BARANGAROO SOUTH

Stage 1B Public Domain Modification S4.55

Project
BARANGAROO STAGE 1B
PUBLIC DOMAIN
Modification S4.55

Drawing Title
WATERMANS QUAY
DETAIL PLAN - NO TREES

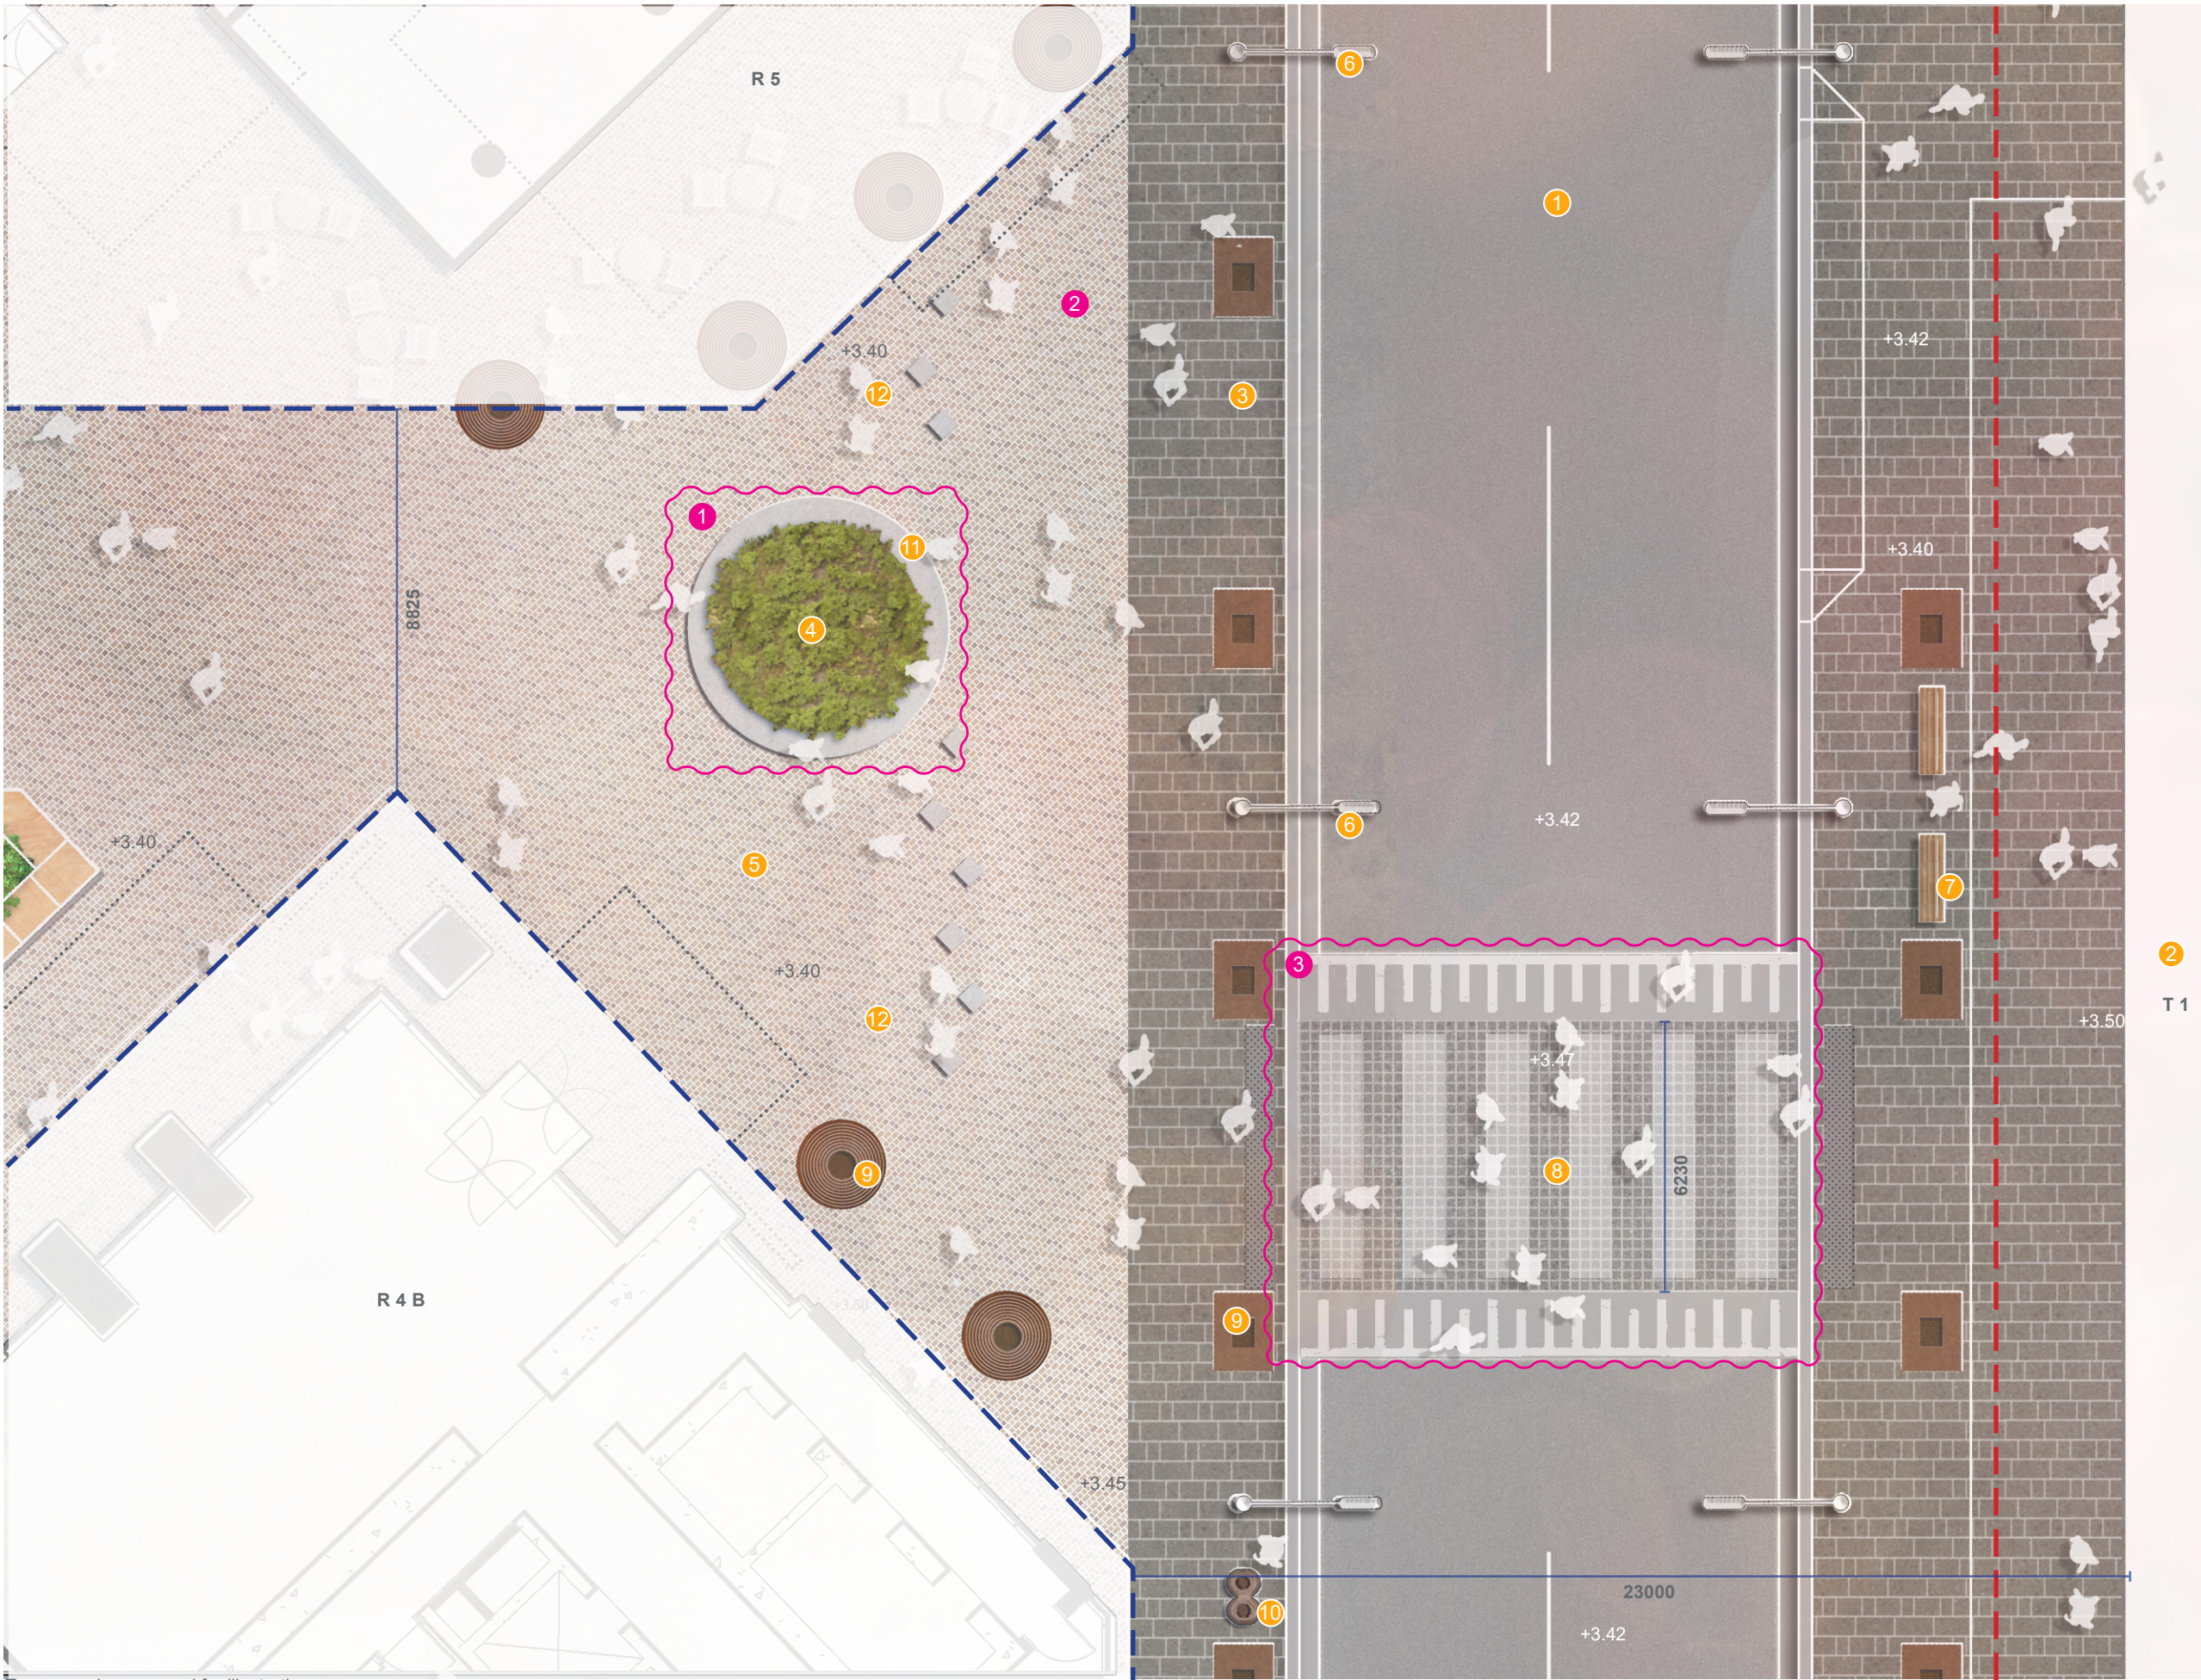
- 1 Remove timber top for Watermans Quay raised planter seating
- 2 Remove porphyry paving to City of Sydney transition as per consent requirement B23
- 3 Reduce size of raised crossing

Drawing Title
BARANGAROO AVENUE
MASTERPLAN
Drawn
SS

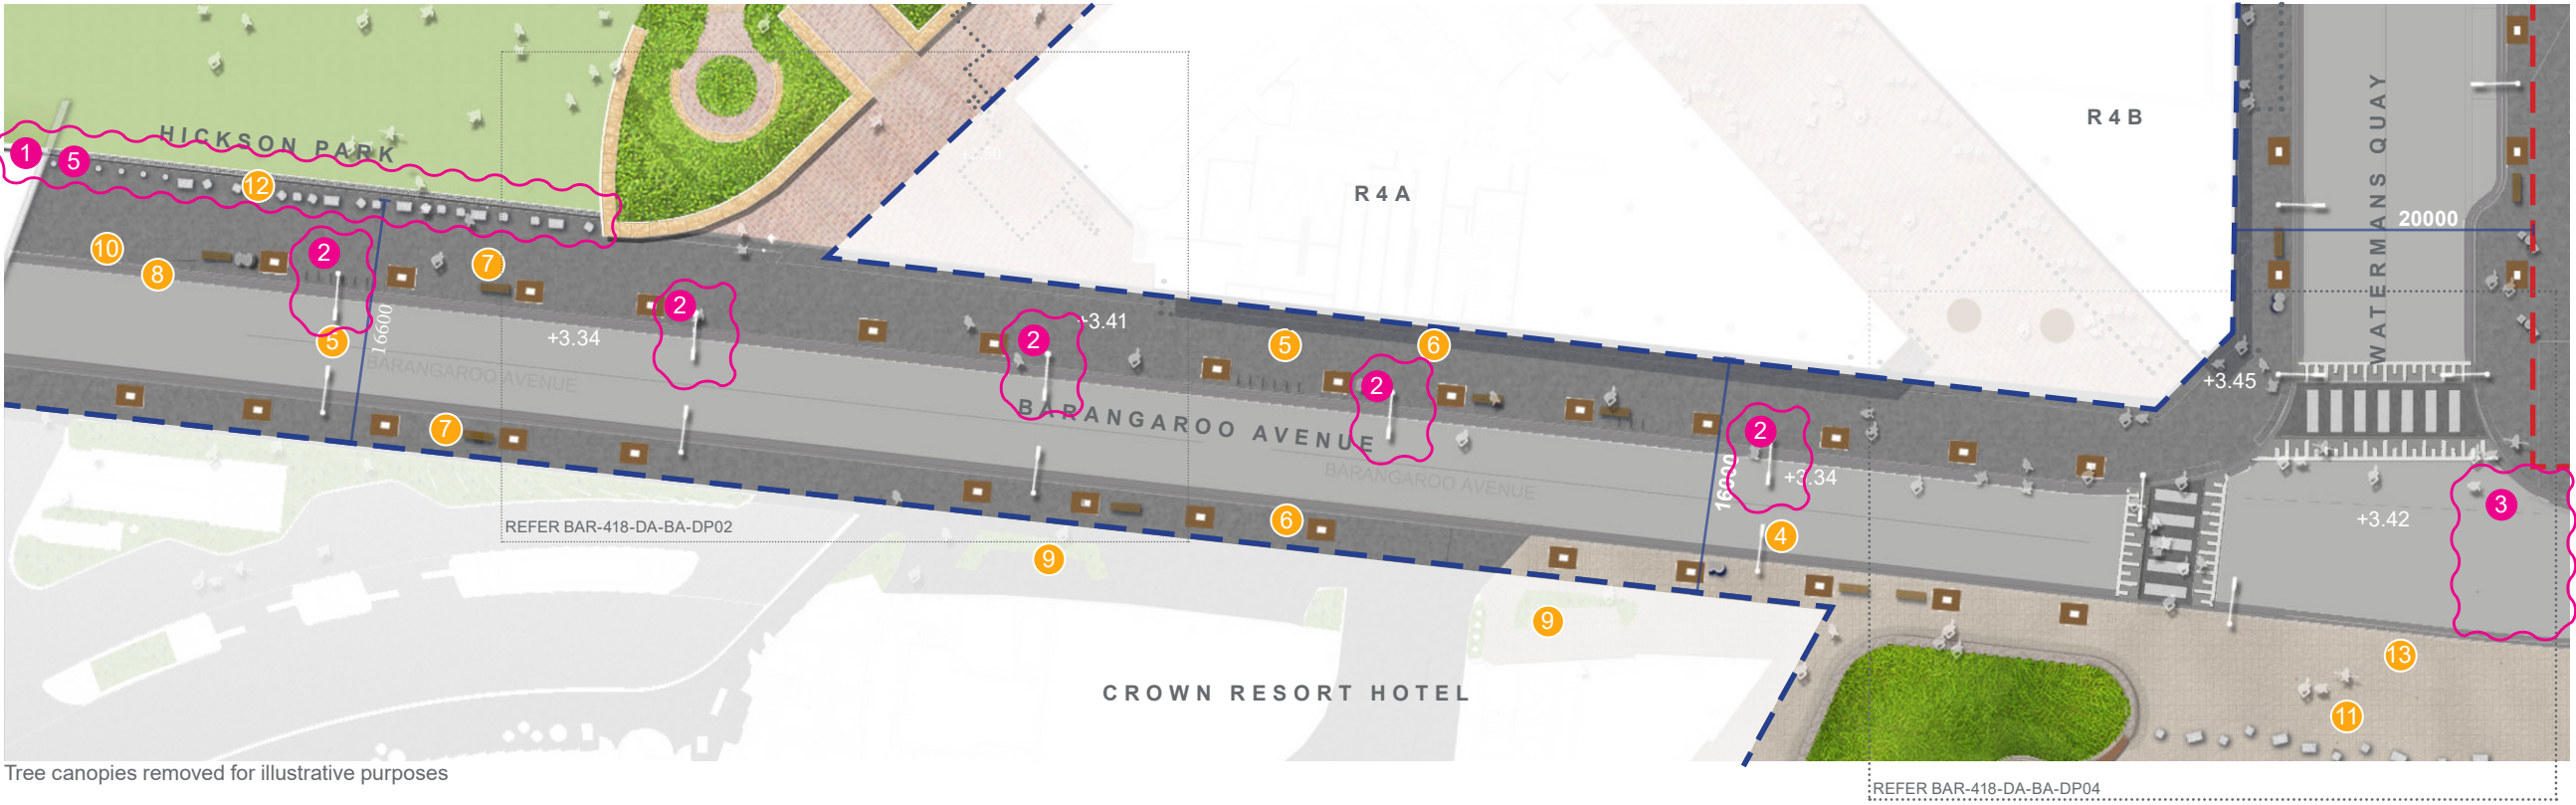
- Proposed Modifications**
- Amendment cloud
- Sandstone paving strip changed to City of Sydney paving along Hickson Park
 - Additional smart pole
 - Deletion of pedestrian crossing
 - Not in use
 - Sandstone bollards changed to concrete & setout amended.
 - Relocated Fig tree to North raised planter

Drawing Title
BARANGAROO AVE NORTH
DETAIL PLAN - NO TREES
Drawn
SS

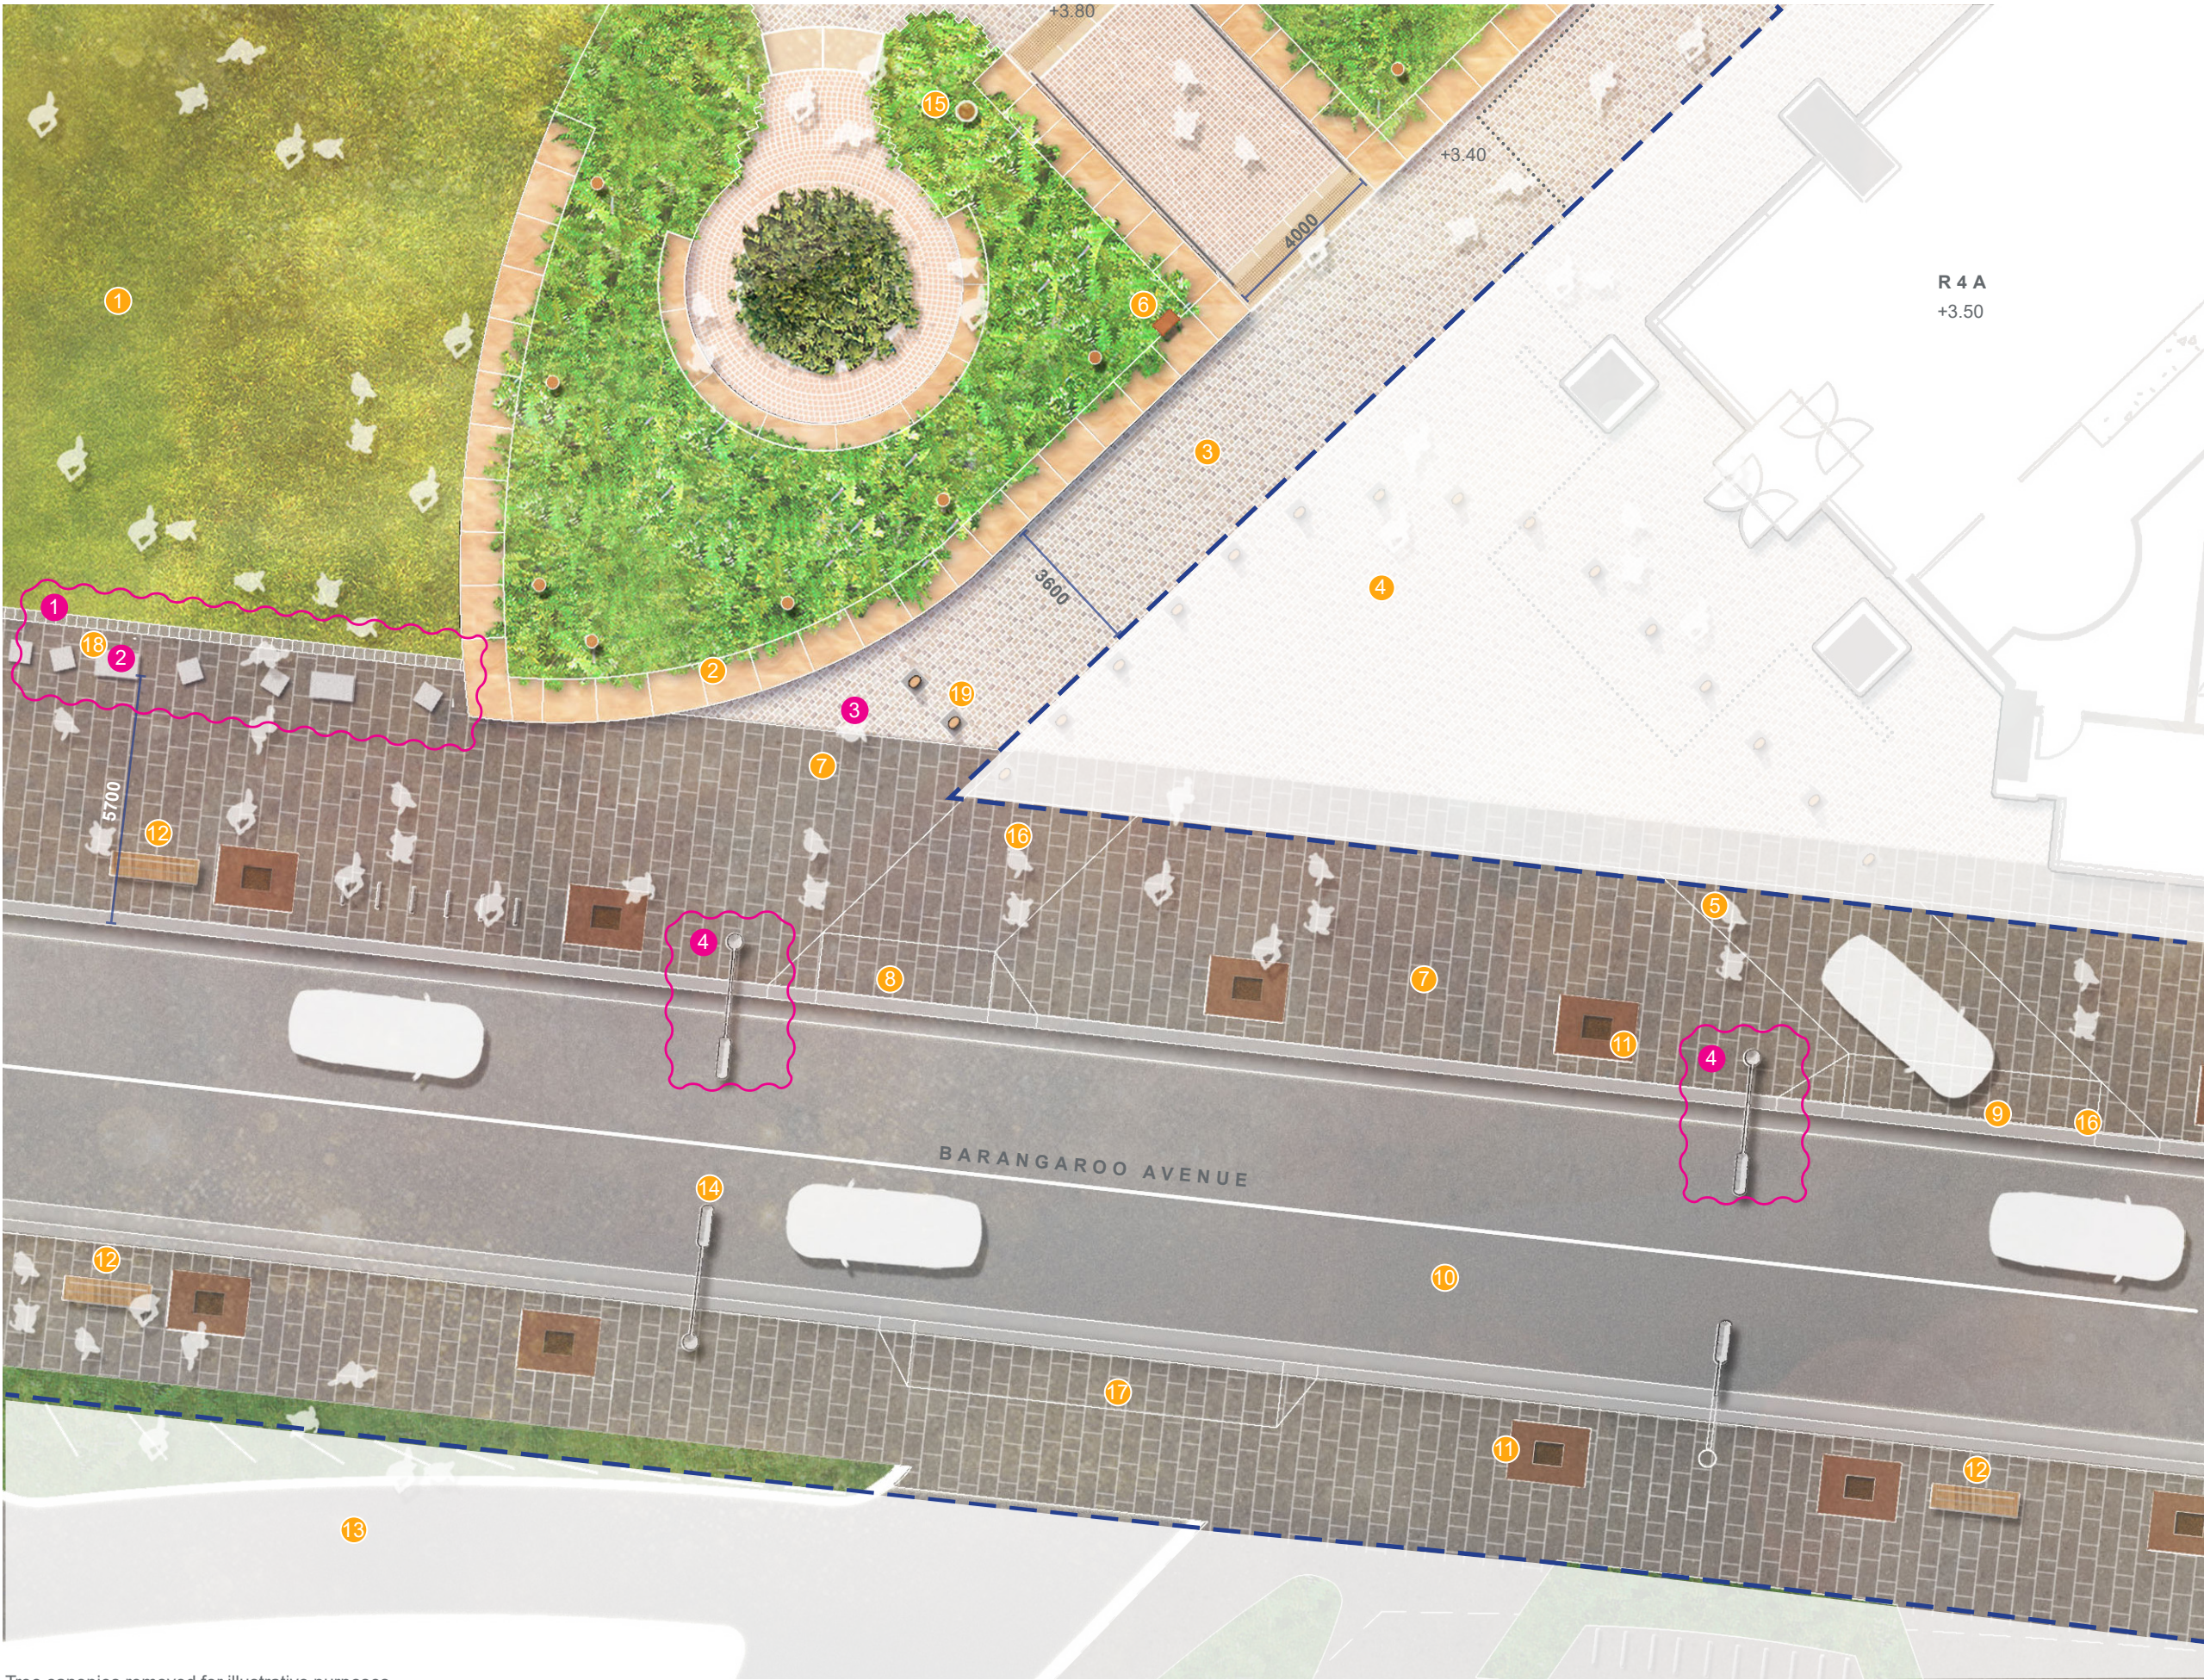
- Amendment cloud
- 1 Sandstone paving strip changed to City of Sydney paving along Hickson Park
- 2 Sandstone bollards changed to concrete & setout amended.
- 3 Remove porphyry paving to City of Sydney transition as per consent requirement B23
- 4 Additional smart pole
